UDNeSS – Circuit Revisions 2.0

XEN Audio

December 2019

Appendix 2.0 Revised Schematics

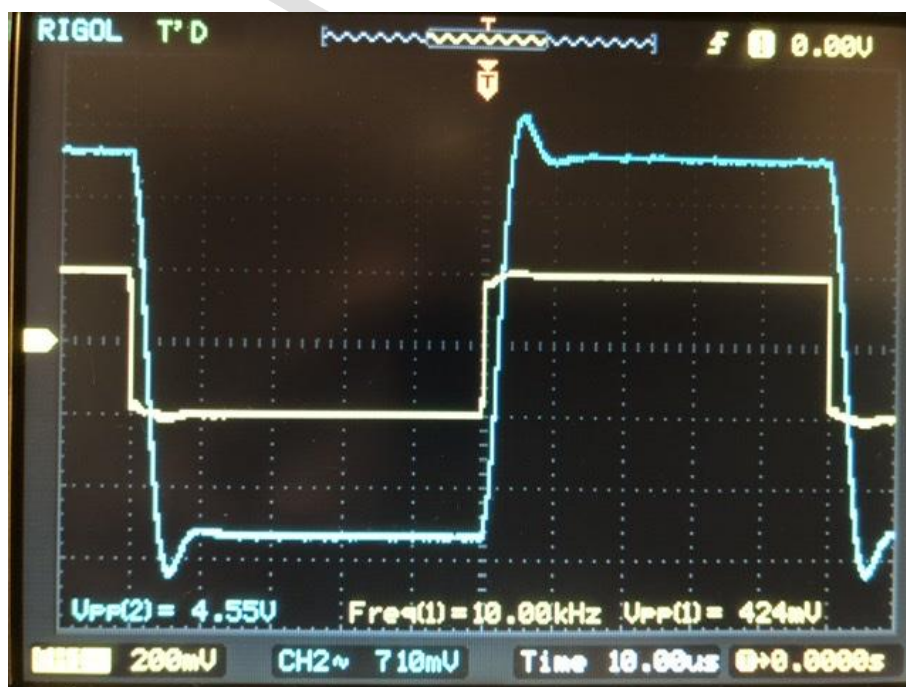
Below is the FFT of the revised circuit at 1kHz, 1W into 8R. H2 is at -72dB & H3 at -85dB.

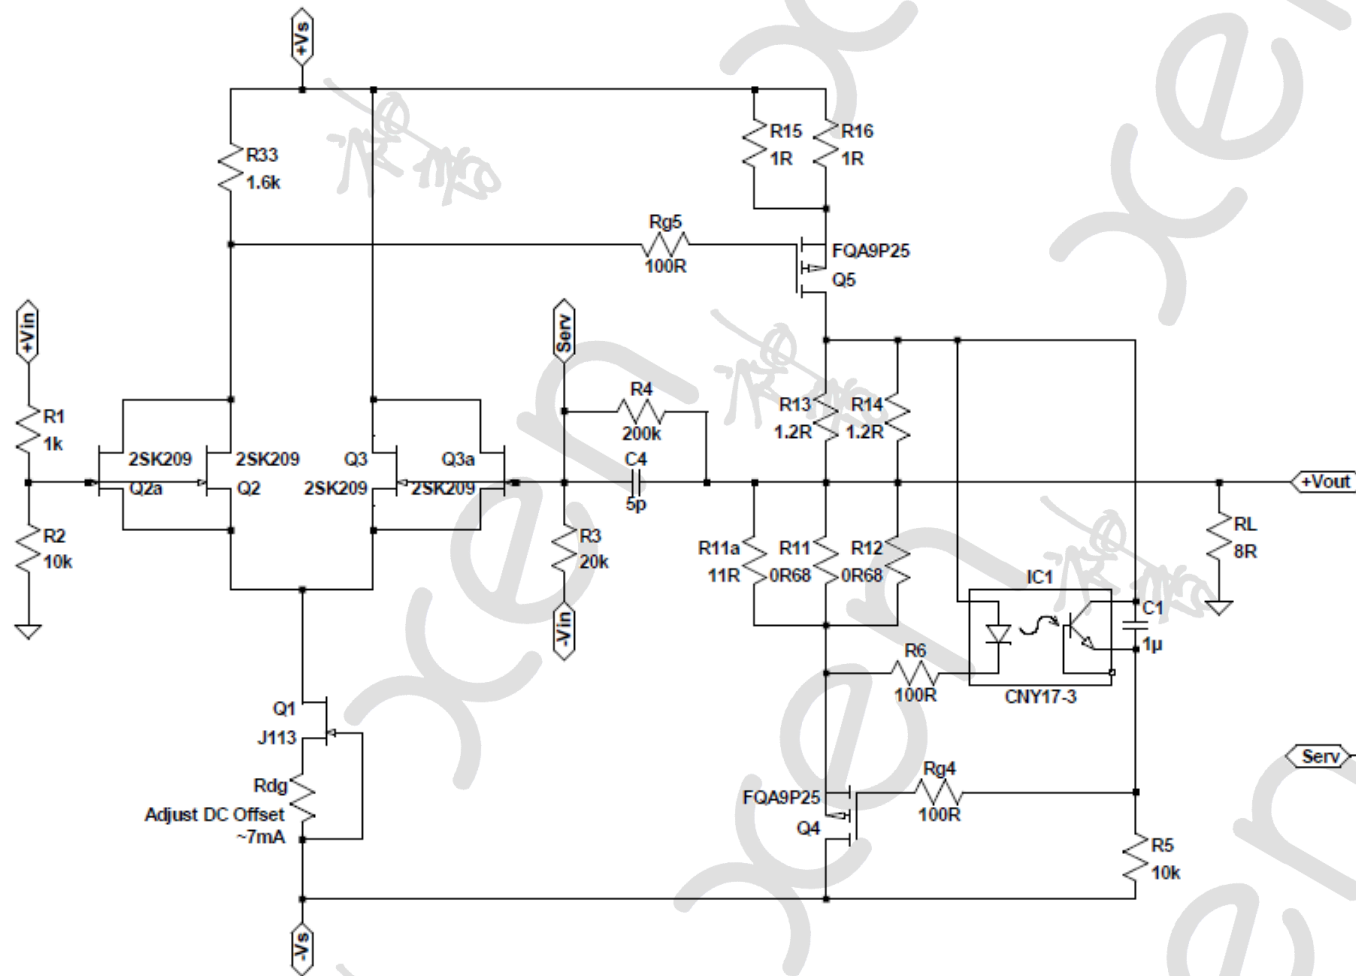
So here are a range of measures that one can choose to achieve the original target performance. After a lot of testing of different configurations, we finally settled on using 4x 2SK209GR to replace 2x J113 for the LTP, and FQA9P25's to replace the IRFP9240's. You can find the revised schematics in Appendix 2.0. We tried to avoid using the cap at the opto-coupler, but it gives so much more stability margin to the circuit that we accepted its deployment in the end. But of course, a low value here would also mean less impact on the H2:H3 ratio.
